Planning Committee

Update Sheet

20/09/21

Item No	Ref No	Address	Recommendation
	21/01727/FUL	Coventry House, Barfield Close, Winchester	Permit

Image 1: Extracted from Stroma's report: North West Corner of the building.

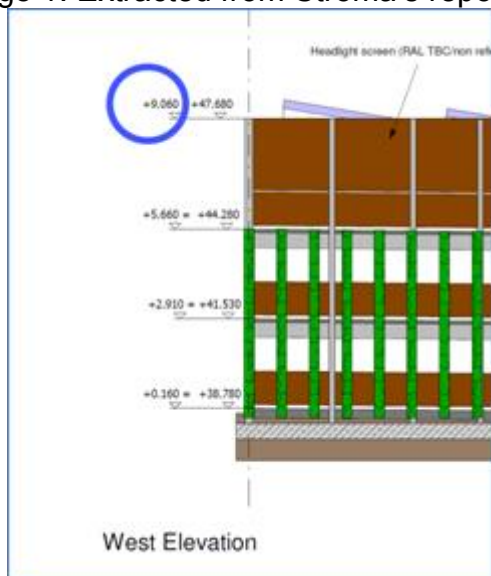
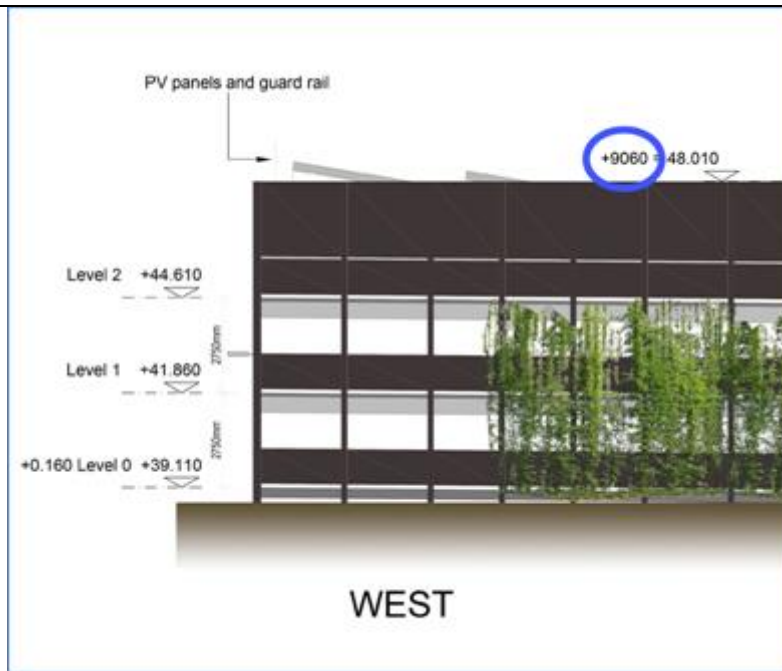
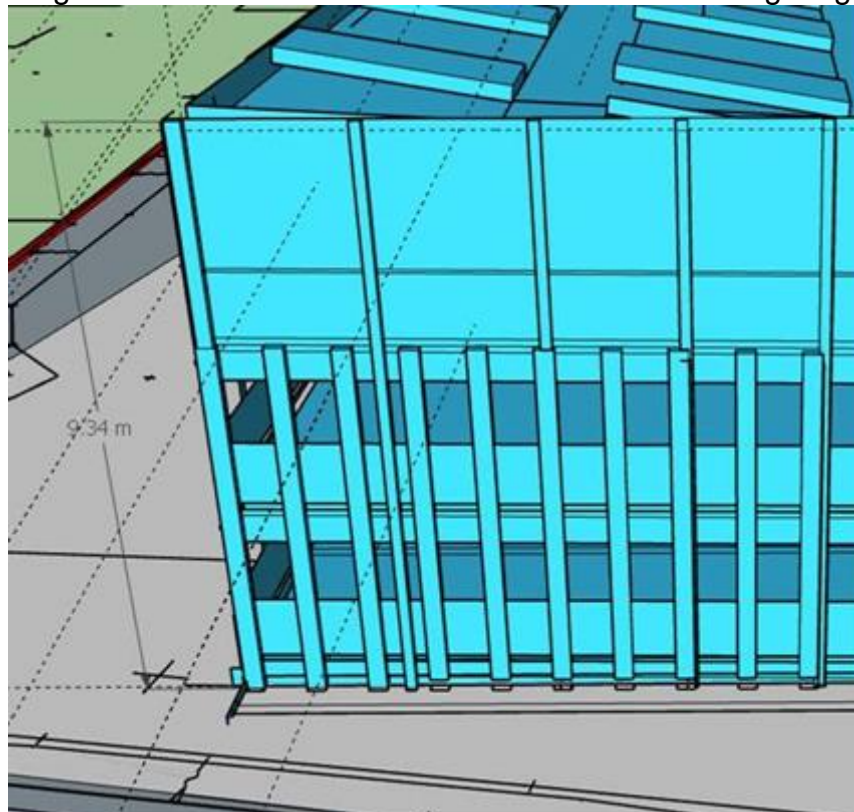
The Daylight and Sunlight calculations have been taken from incorrect drawings which are not the application scheme drawings. Appendix D of the assessment contains the drawings used. These show on the west elevation a height at the top of the level 2.5 screen and west stair core of 48.495 m AOD. The relevant

application drawing is VTX-STL-X-ZZ-DR-A-XXXX-0201 Revision PL01. That shows this staircase and screen at 48.825 m AOD. The level 2 screen is similarly higher in the application drawing: 48.010 m AOD compared to 47.680 m AOD in the Daylight and Sunlight Assessment.

The drawings referenced in the daylight/ sunlight report were used by Stroma to construct the building in the model and therefore the AOD values were not taken into account. The drawing Stroma used was produced during the first application. In short they used an outdated drawing with the wrong AOD values but the correct building size. The model therefore does not use or rely on the AOD values for the proposed building. The model itself is a relative representation of the site, including Domum road. Survey data was used to build a 3D model of the area to produce the level differences between the development and Domum Road. The scheme does not propose any substantial change in levels on the development site.

The drawing included in Stroma's report shows that the North West corner of the building is 9.060m from ground level (See image 1). Drawing number VTX-STL-X-ZZ-DR-A-XXXX-0201 Revision PL01 included as part of the application shows the same value (See image 2).

Image 2: North West corner of the building taken from VTX-STL-X-ZZ-DR-A-XXXX-0201 Revision PL01

The model used in the Daylight/ Sunlight report is actually slightly bigger which has an effect greater than that of the proposed development. Instead of modelling a building that is 9.060m on this corner, they have in fact modelled it at 9.340m (See image 3). It is Stroma's standard practice to model the building slightly larger so that if there are any future changes or issues, the model and report does not need to be regenerated. It also compensates for construction tolerances so that the effect of the finished building will always be less than the modelled structure.

Image 3 from model: Corner at west elevation showing height of 9.34m
